**From:** Amadi, Eric A - DNR  
**Sent:** Tuesday, November 23, 2021 6:25 PM  
**To:** Julie A Zimdars  
**Subject:** FW: BRRTS 02-41-553761 and 06-41-560068 Connell Wabash Site - RAOR Addendum/Pre-Design Work Plan (Rev 2)  
**Attachments:** BRRTS 0241553761 & 0641560068 Connell Wabash RAOR Addendum R2 Sep 28 2021.pdf

Hi Eric – On behalf of Connell Aluminum Properties, attached is the *Addendum (Revision 2) to the Remedial Action Options Report (RAOR) and Pre-Design Sampling Work Plan* for the Former Koppers Tar Plant and Wabash Alloys Site that incorporates WDNR comments received on July 9, 2021.

**Addendum (Revision 2) to Remedial Action Options Report (RAOR)  
and Pre-Design Sampling Work Plan - Connell Aluminum Properties, LLC  
Former Koppers Tar Plant and Wabash Alloys Site  
9100 S. 5<sup>th</sup> Avenue, Oak Creek, WI 53154  
BRRTS# 02-41-553761, FID#241379050  
Connell VPLE BRRTS #:06-41-560068**

FIGURE NO.  
C8

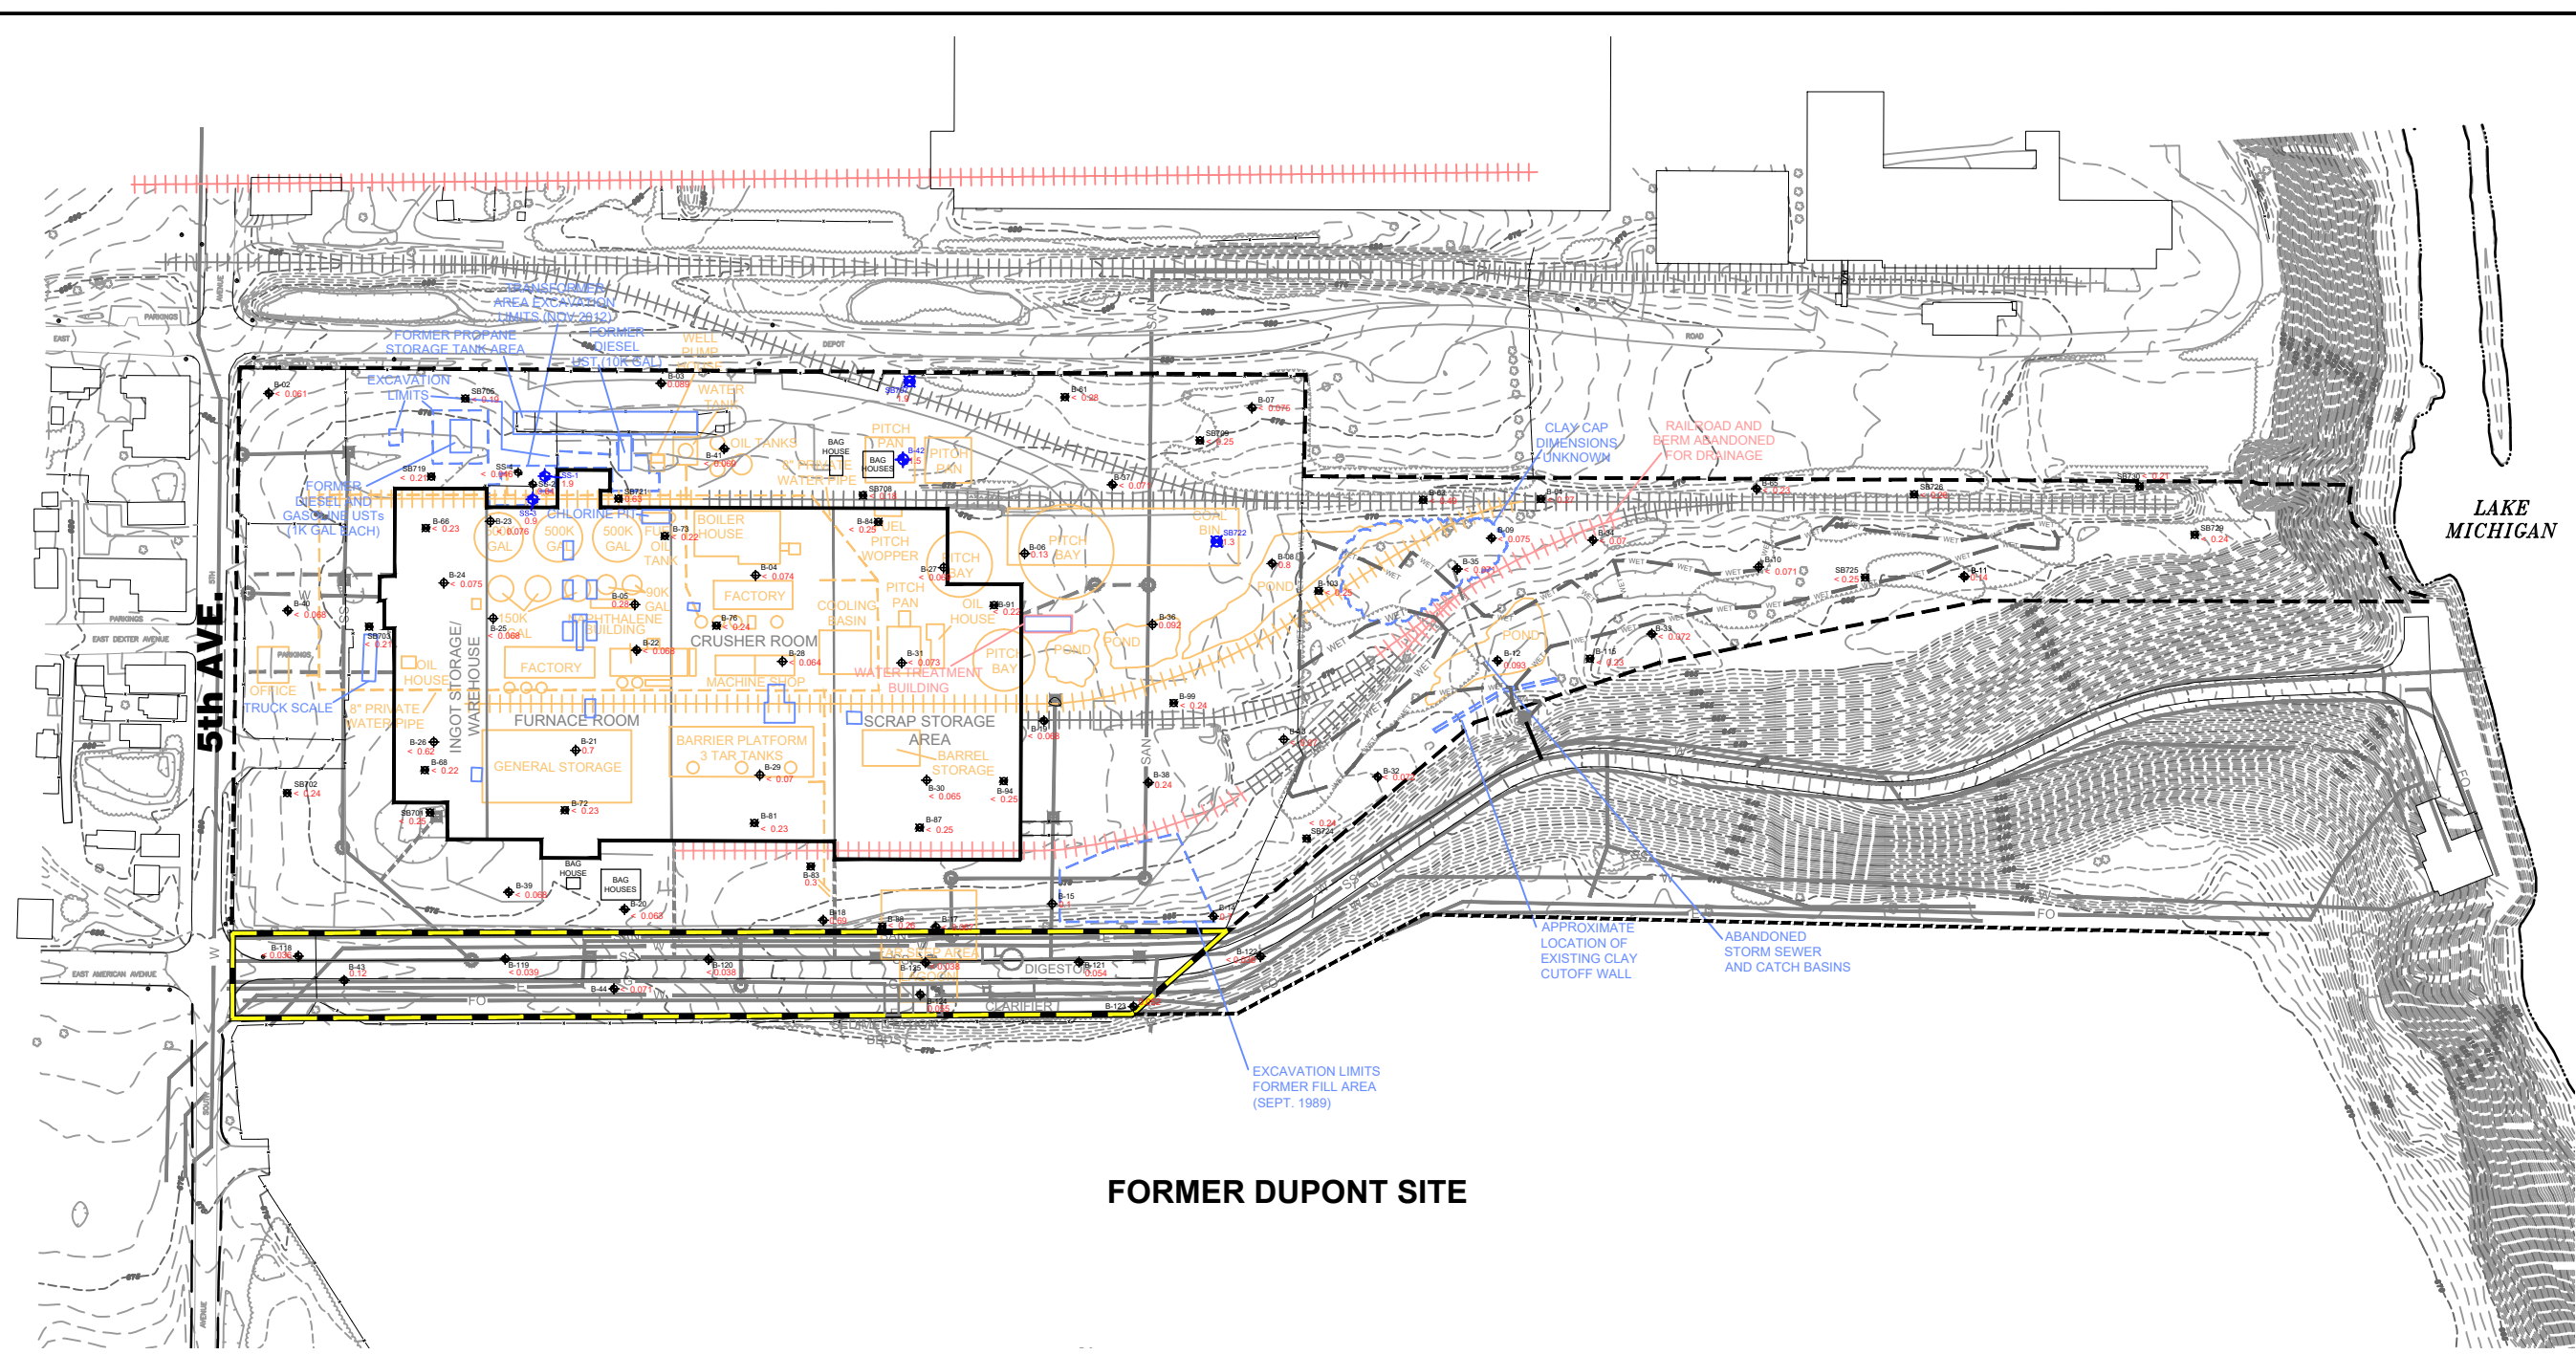
On January 27, 2014, NRT resubmitted the SI Report Figures C4 (Chromium, 0-4 ft bgs) and C8 (Silver, 0-4 ft bgs) after realizing an error on the figures that did not match the tables for chromium and silver (NRT transmittal dated January 27, 2014 is attached). Note that the data for B-08 has been corrected on these figures and are attached.
